Diameter Change of Lead Wire

Part Number: ECKD4C681MDV , ECKD4C102MDV

ECKD4C---MDV (current)

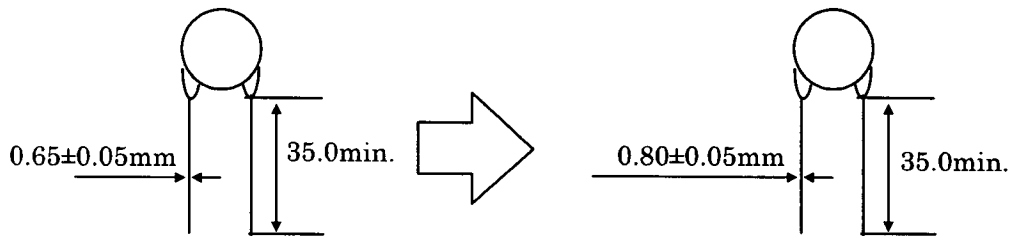
*Diameter Change of Lead Wire

0.65±0.05mm ⇨ 0.80±0.05mm

*There are not changes of characteristic or others dimension.

ECKD4C---MDW (after)
